This Value Engineering report summarizes the results of the Value Engineering study performed by Ventry Engineering for the Kentucky Transportation Cabinet. The study was performed during the week of February 2-6, 1998.

The subject of the study was the I-75 Widening from KY 36 to KY 491 (Williamstown to Crittenden).

Sherman - Mt. Zion / I-75 As-Proposed

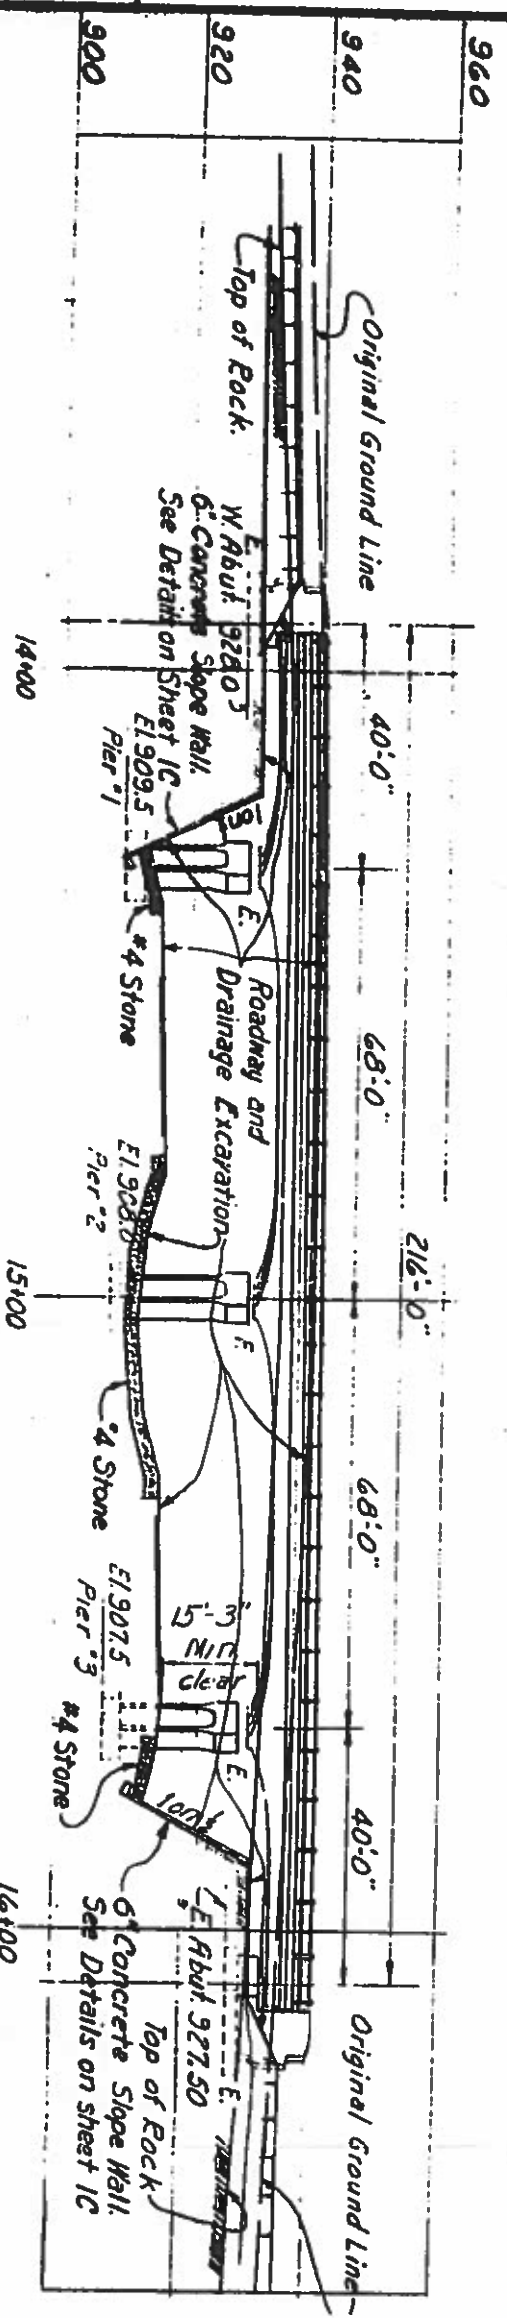
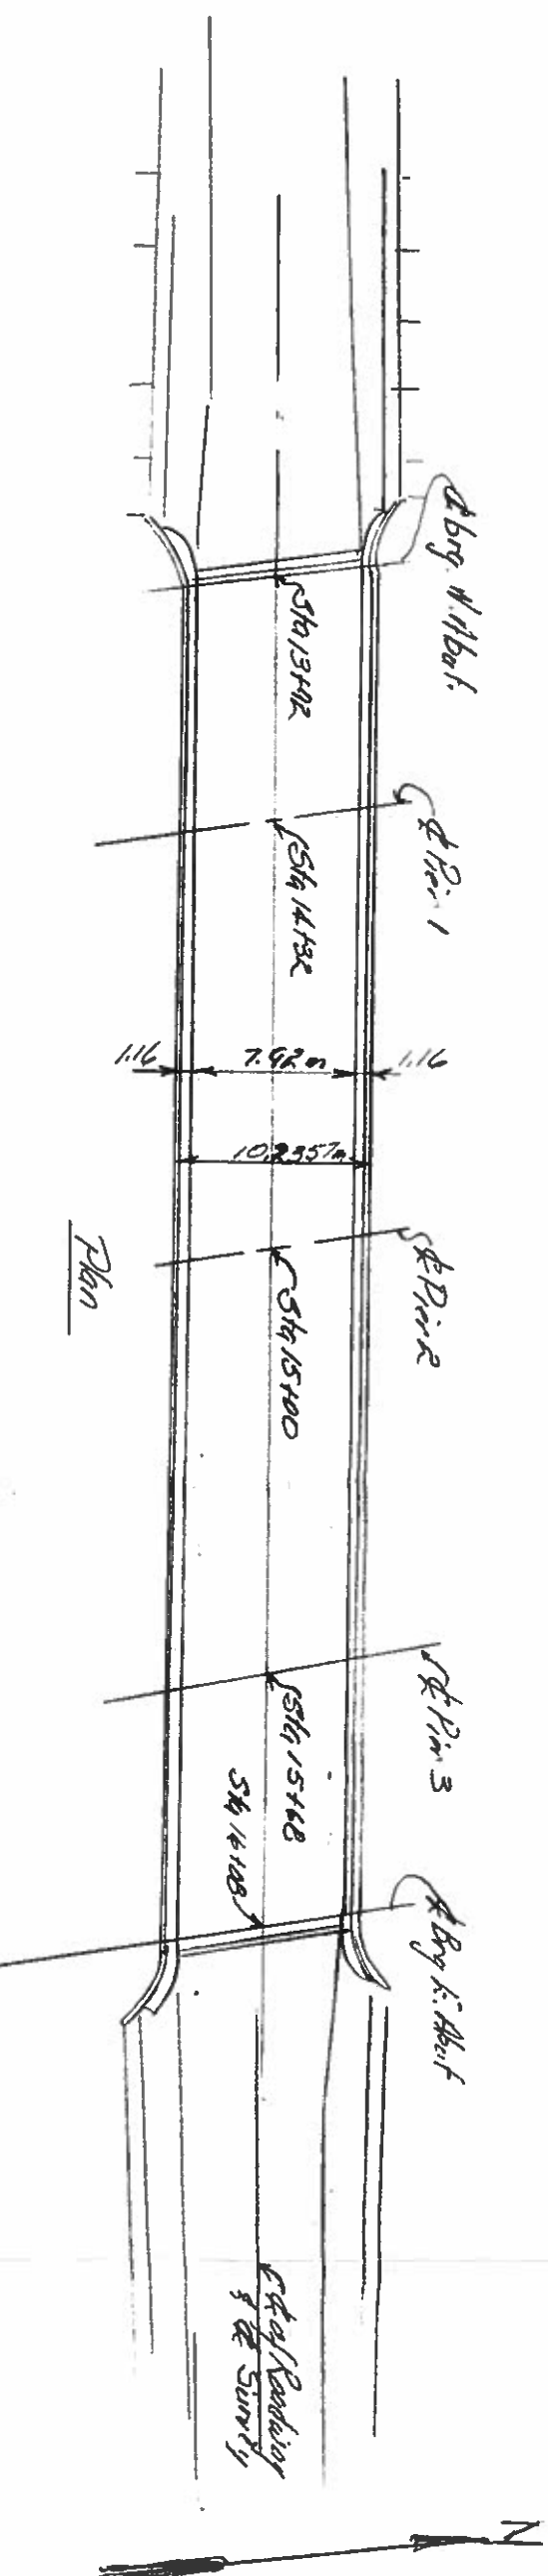
The "As Proposed" recommendation is to jack the existing bridge to provide the required 16'6" vertical clearance. A site visit and the inspection report indicate the deck is delaminating and needs repair. Therefore, the "As Proposed" will include the cost of a deck overlay.

Sherman - Mt. Zion / I-75
VE Alt.

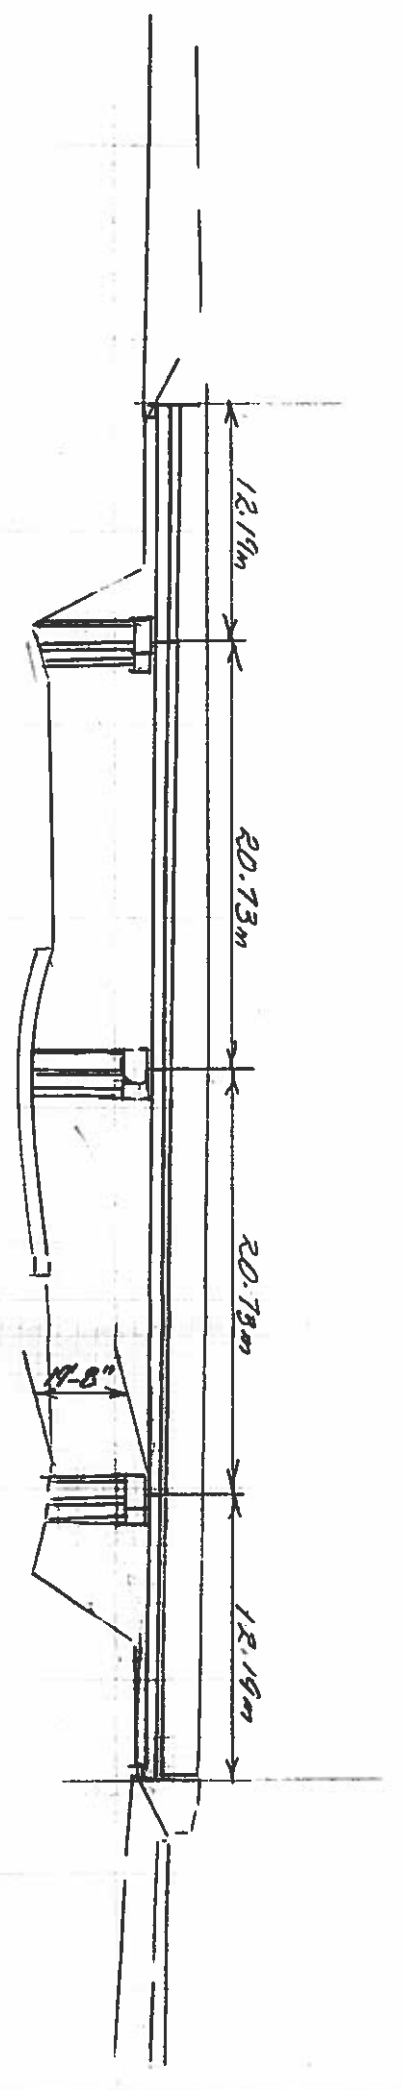
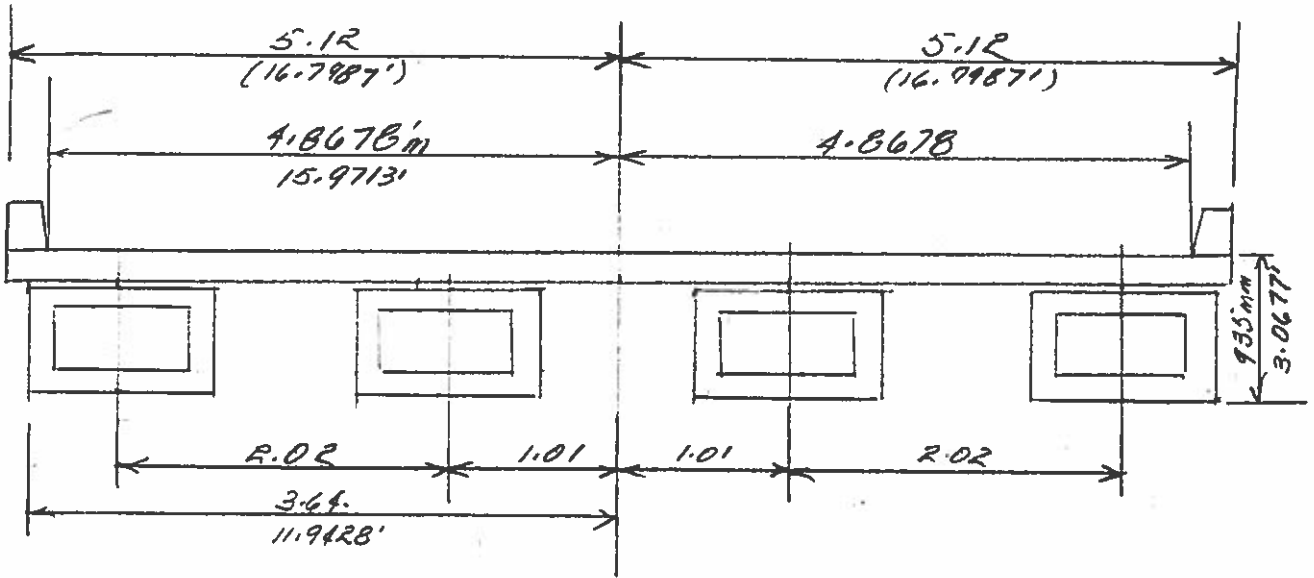
Value Engineering Alternative No. 1 is to remove the existing superstructure, rebuild the existing substructure to accept a new box beam bridge with current geometric requirements. This alternative reduces the amount of Sherman-Mt. Zion reconstruction required for this project. Also, the new superstructure would have a longer service life than the jacked-up existing superstructure. The Value Engineering alternative would save approximately \$28,000.

Crittenden - Mt. Zion / I-75
 VE-1

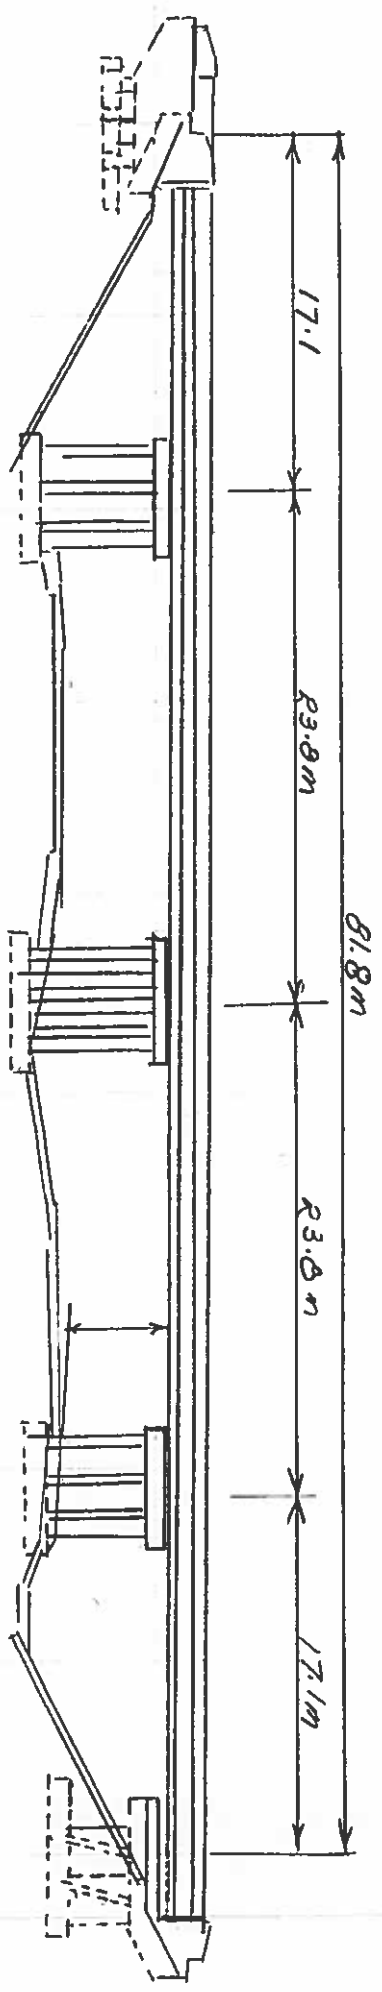
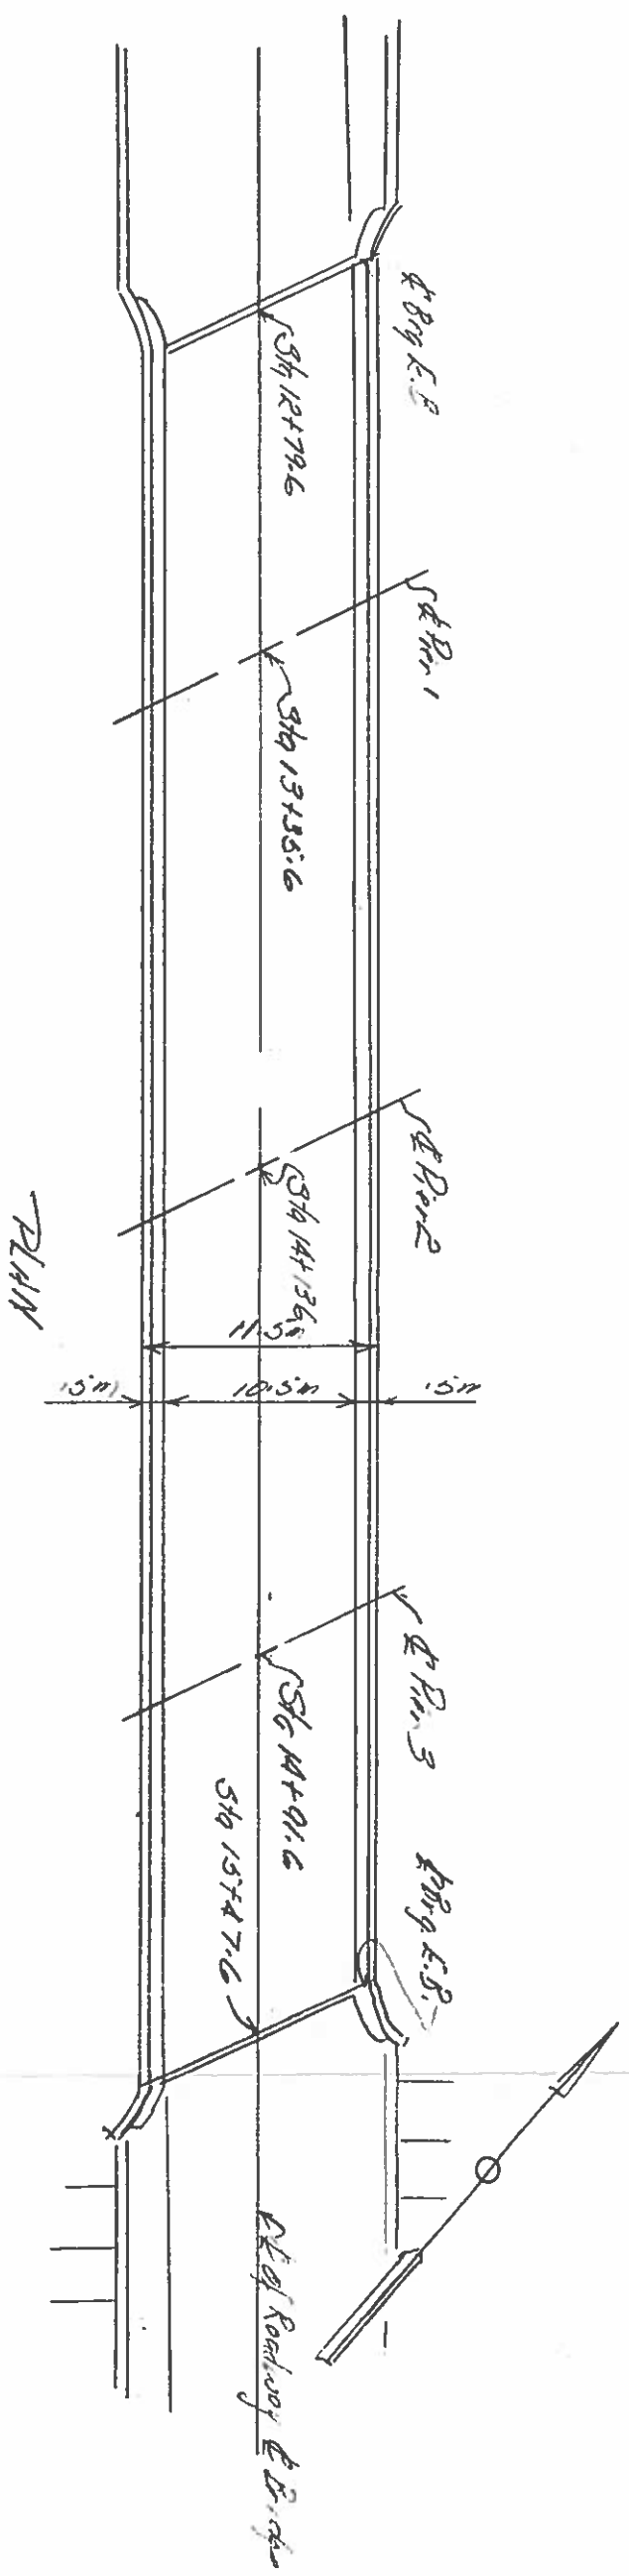
The Value Engineering Alternative No. 1 utilizes the existing substructure and a new superstructure. The new superstructure will utilize box beams and the width of the new superstructure will meet current standards. The substructure will be rebuilt to accept the new superstructure and to provide 16'-6" of vertical clearance. This alternative will provide longer service life than the "As Proposed" and save approximately \$670,000.
